## ADDENDUM NO. ONE (1)

SIGN-IN SHEET for ITB#6- 2016/2017 GCSC SOFTBALL COMPLEX PROJECT

TYPICAL LIGHTING CONTROL WIRING DIAGRAM "A"  
 NOT TO SCALE (OFFICE)

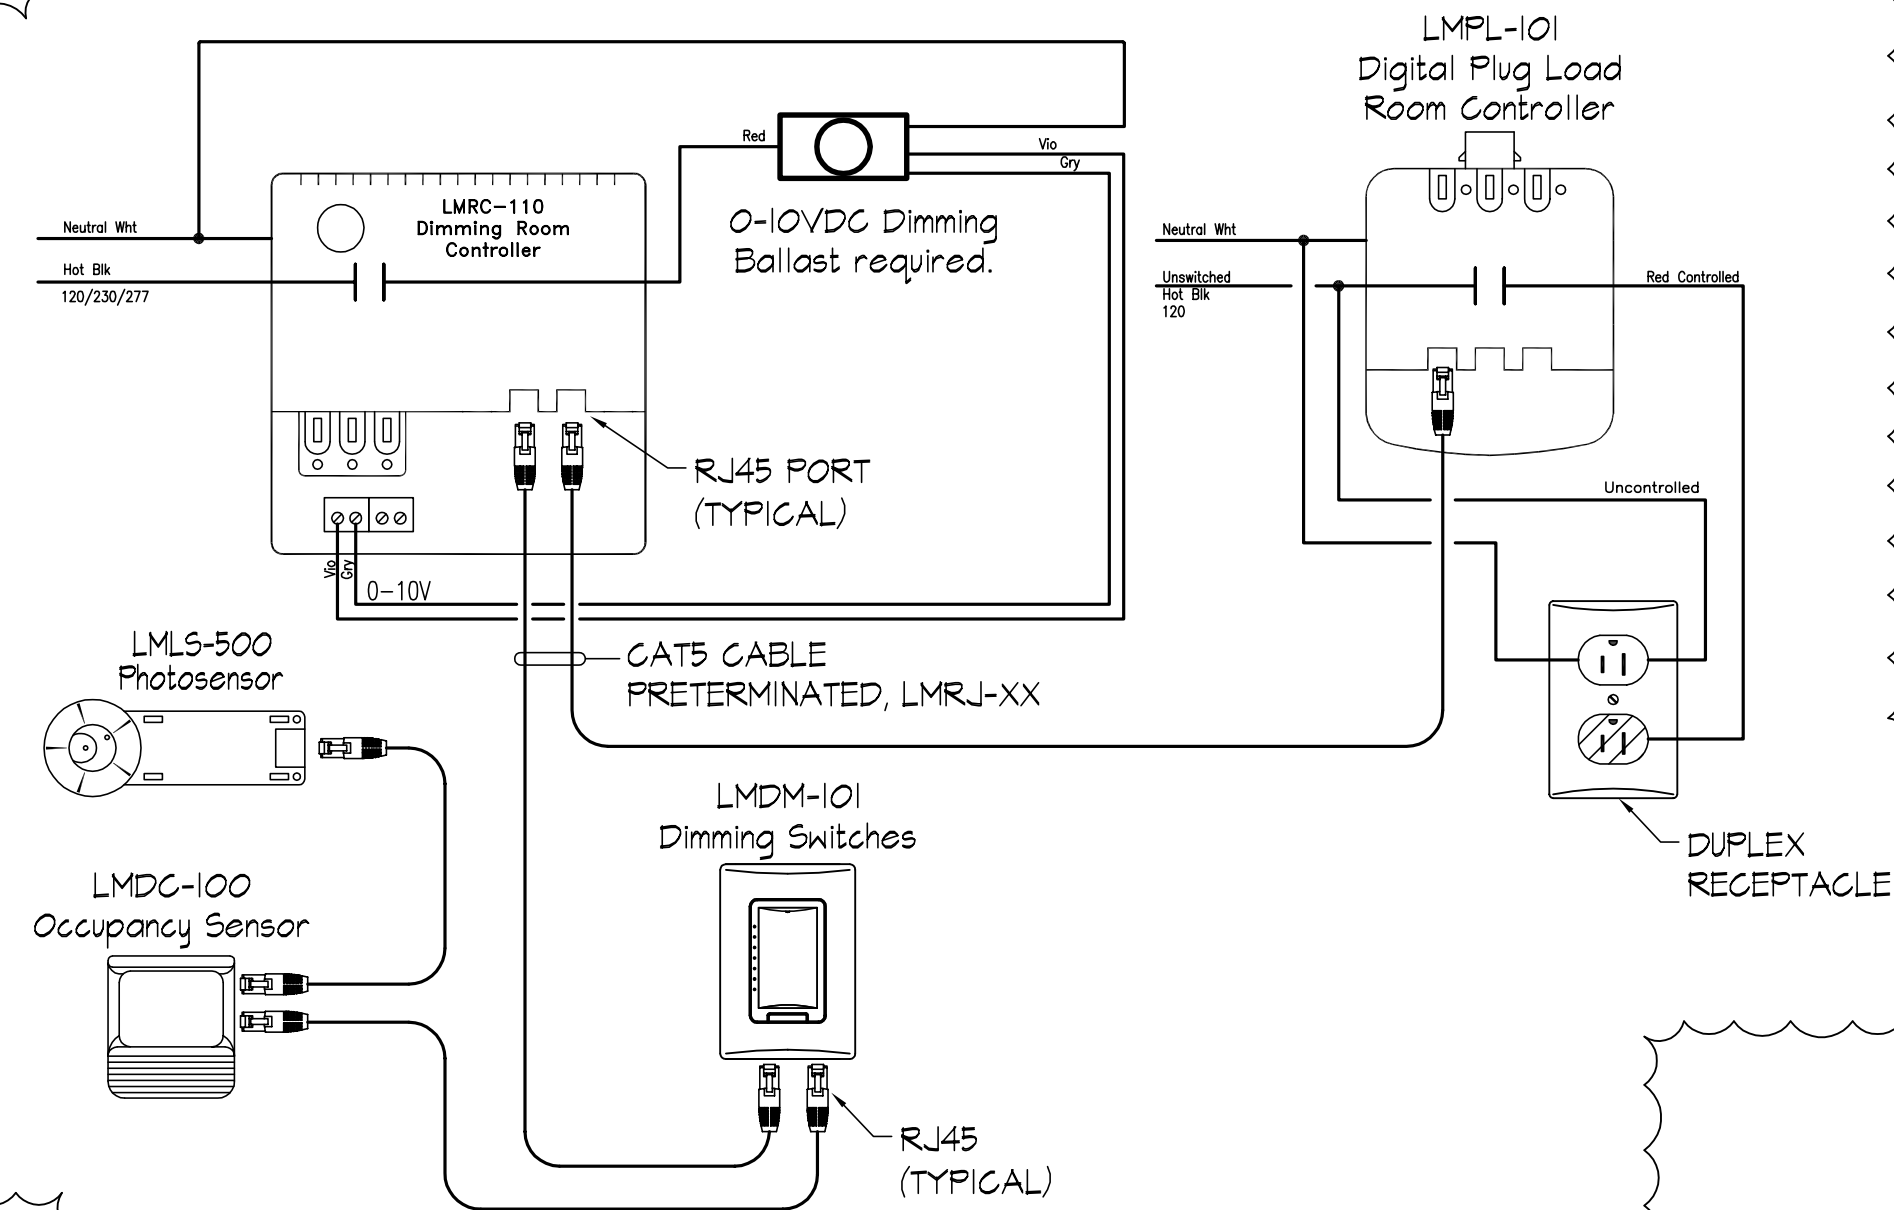
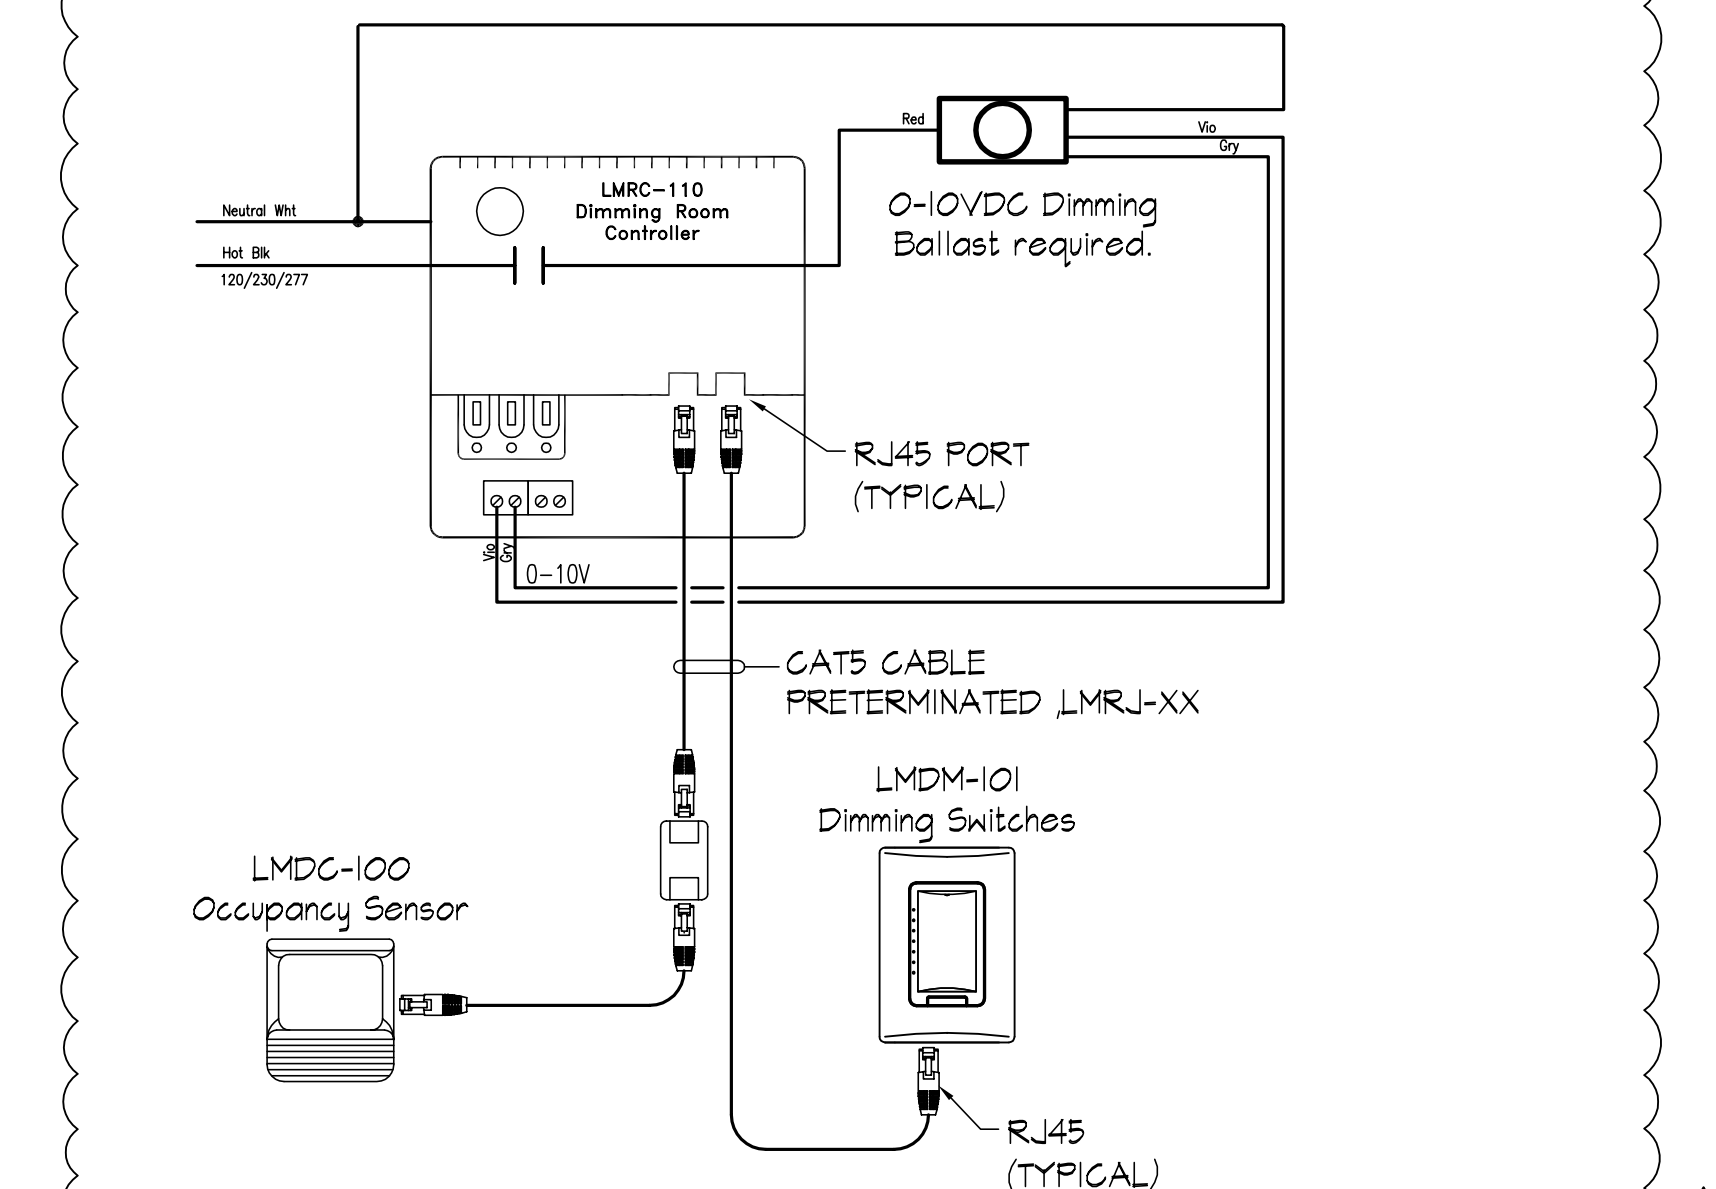
Item No. 2E: Refer to Drawing Sheet E2, Electrical Legend:

- a. **CHANGE** Manufacturer and model numbers for occupancy, daylight sensors and lighting controls.
- b. **ADD** Lighting Control Wiring Diagram.

SHEET TITLE:  
**ELECTRICAL HOME  
 LOCKER FACILITY**  
 PROJECT NO. 4226 SHEET E5

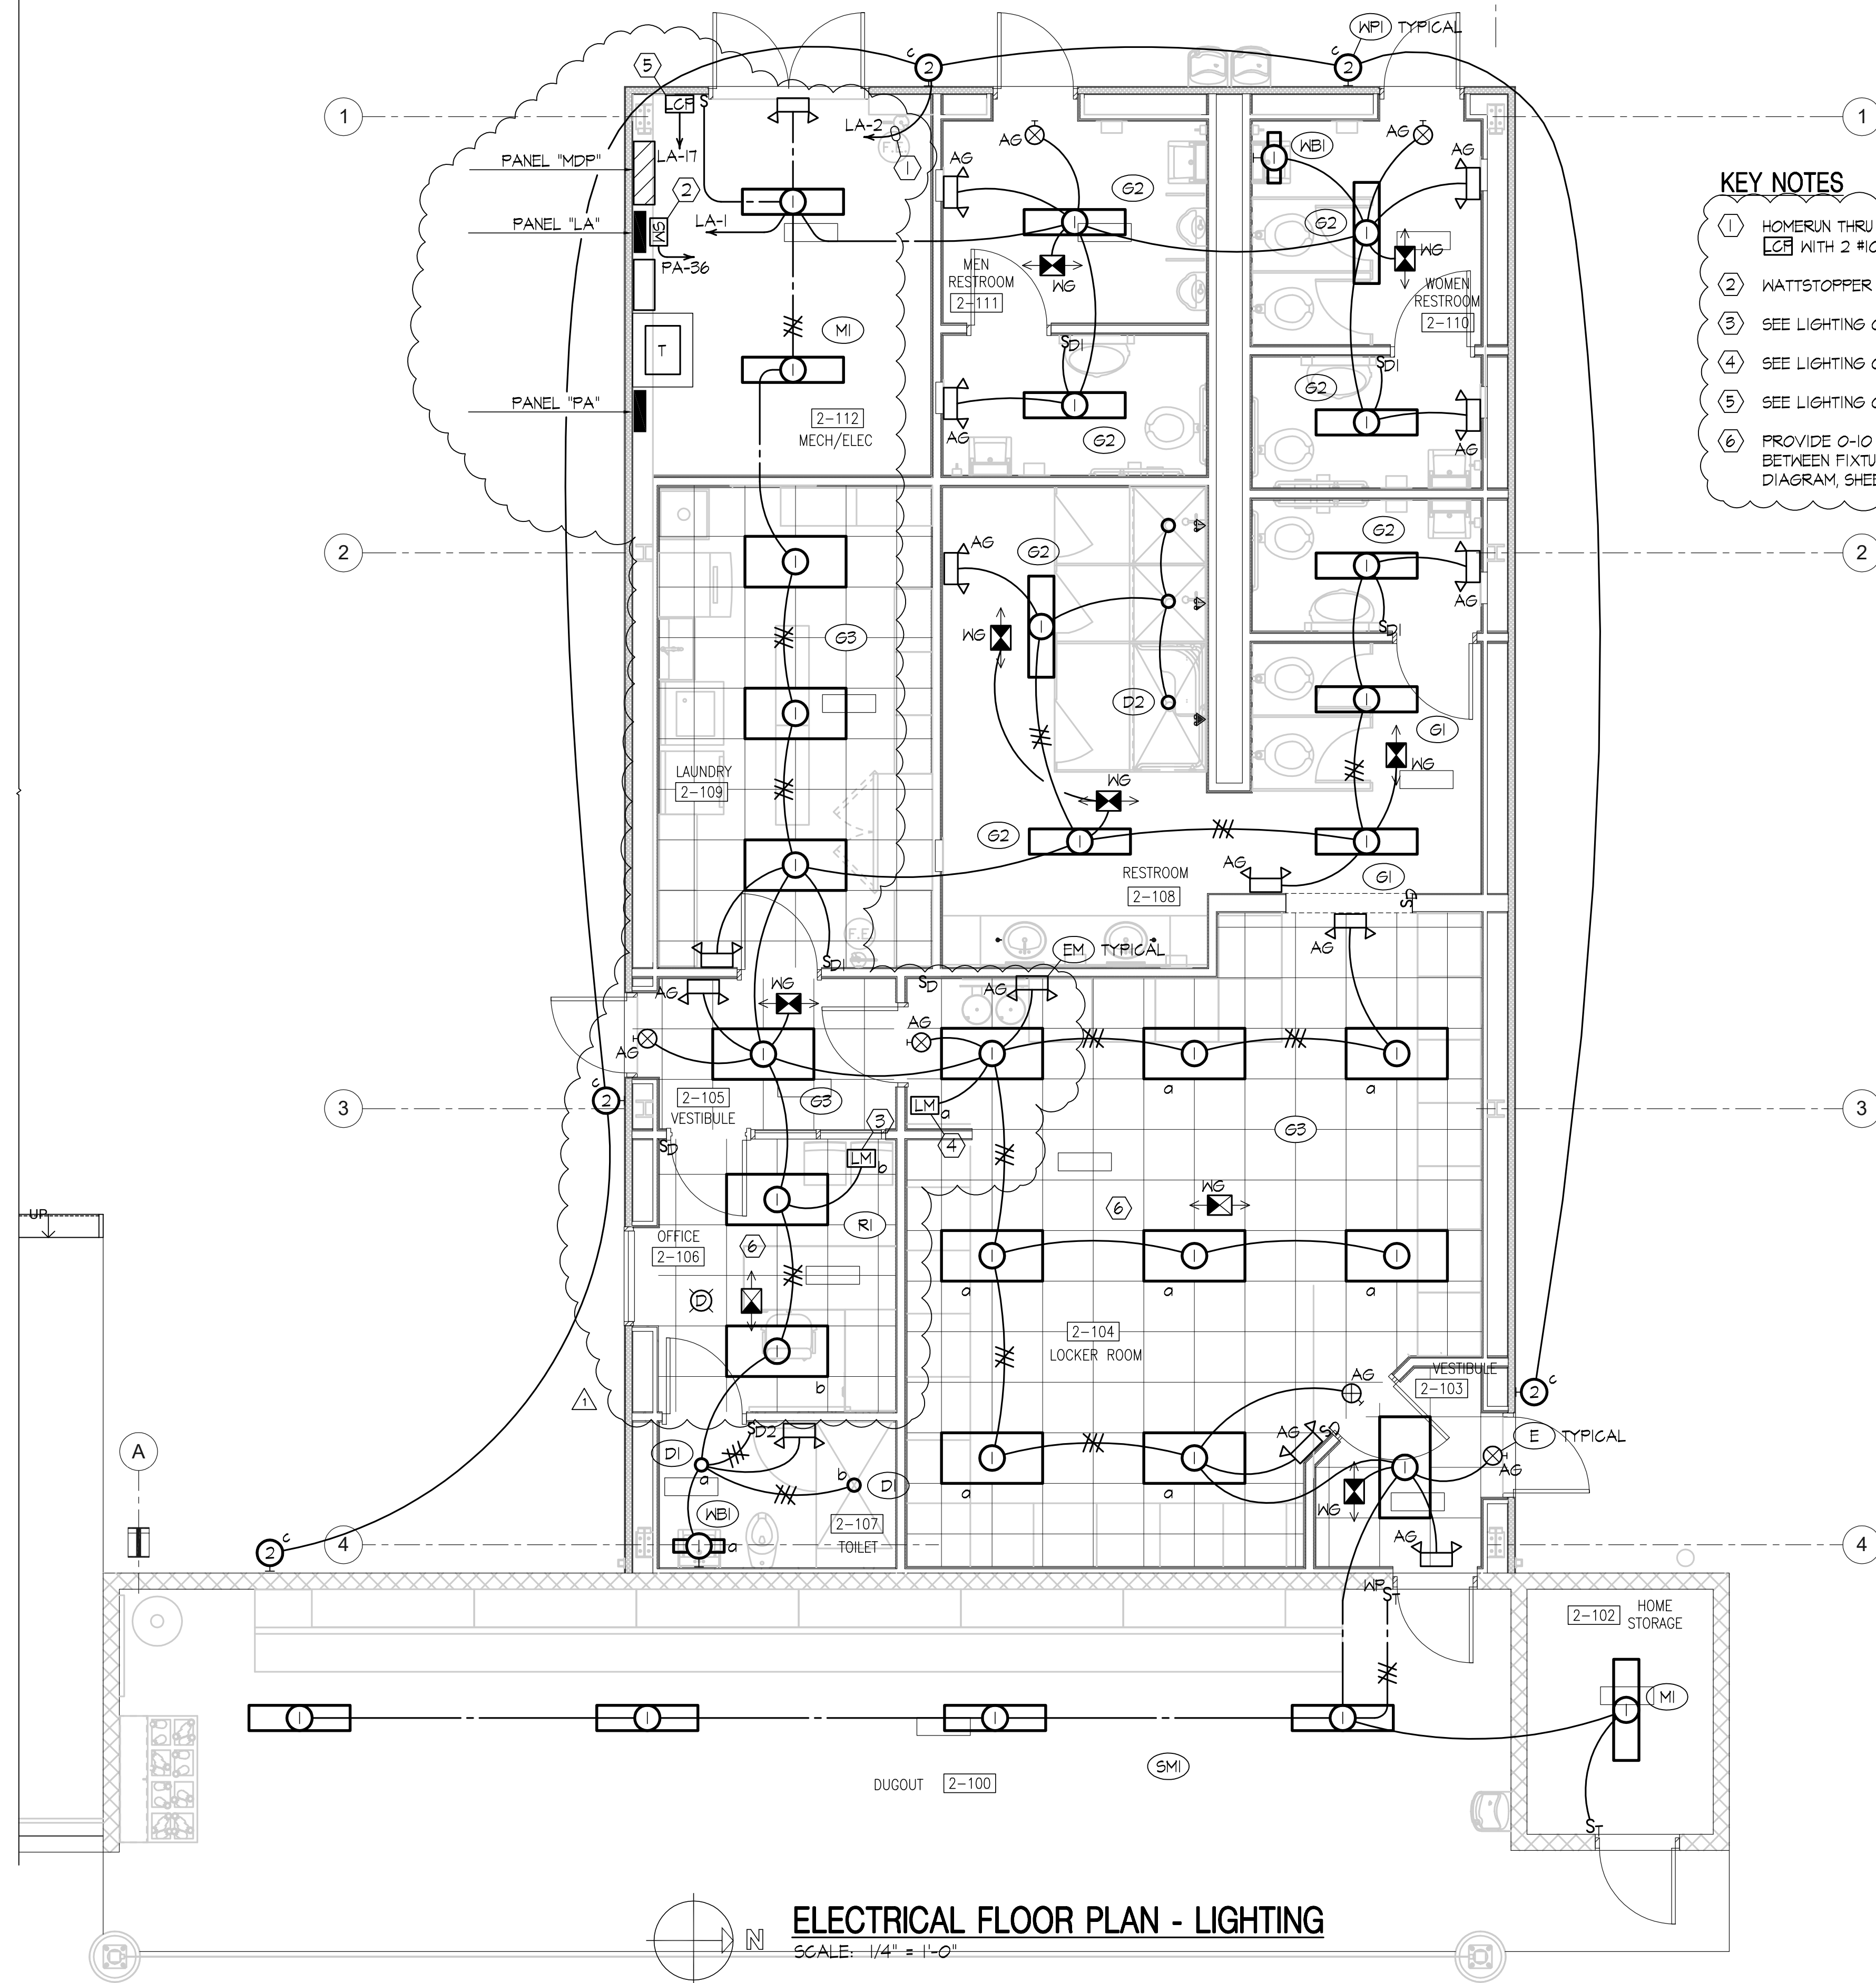
Item No. 4E: Refer to Drawing Sheet E5, Electrical Home Locker Facility:

- a. **CHANGE** Wiring/circuiting for Office, Locker and Laundry areas.
- b. **ADD** WattStopper Lighting Control panels and circuiting.
- c. **CHANGE** General Note.
